DESIGN <i>KE</i>	DRAWN BY <i>KE</i>	DART AEROSPACE LTD HAWKESBURY, ONTARIO, CANADA	
CHECKED <i>RF</i>	APPROVED <i>[Signature]</i>	DRAWING NO. DSI 9141	REV. A SHEET 1 OF 2
DATE 99.03.02		TITLE 350/355 BEARPAW	SCALE NTS
A	99.03.02	NEW ISSUE

DART SERVICE INSTRUCTION

AMEND DRAWING D350-578 REV. C

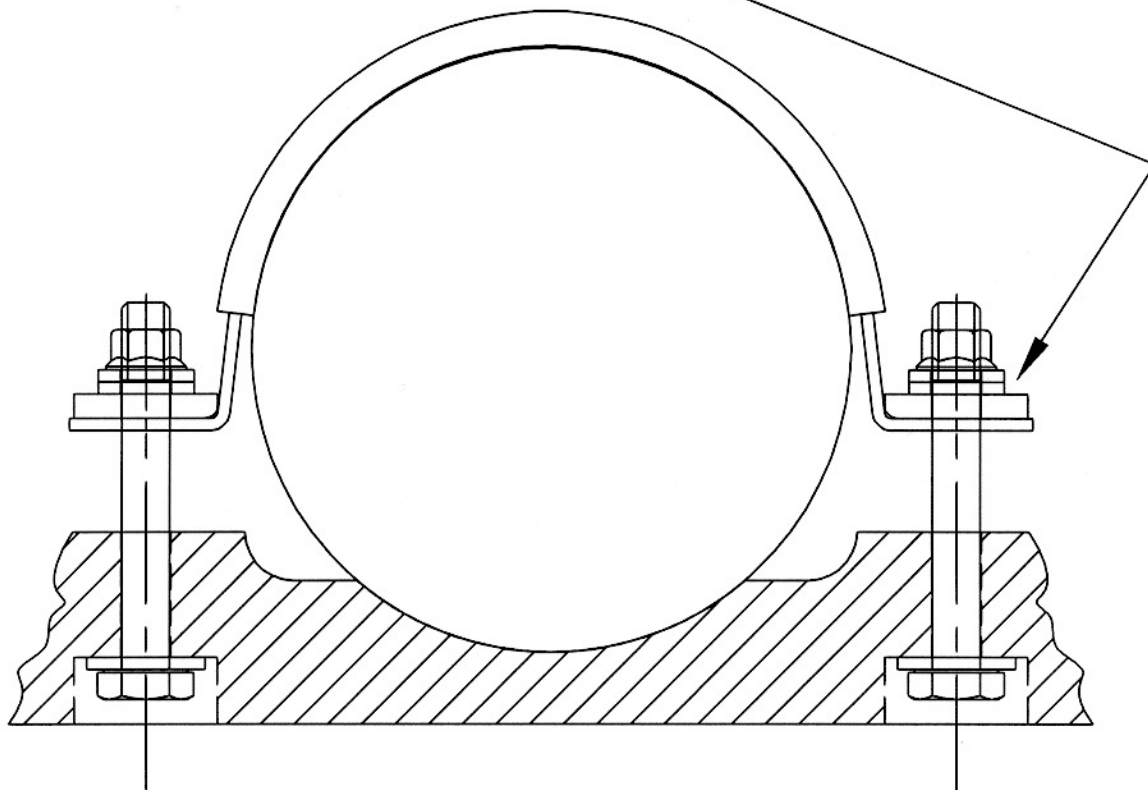
REPLACE AN4-13A BOLTS WITH AN4-17A BOLTS. ADDITIONAL
AN960JD416 WASHERS MAY BE ADDED UNDER NUT TO ENSURE
2-4 THREADS IN SAFETY

REMOVE D2022-101 SPACERS
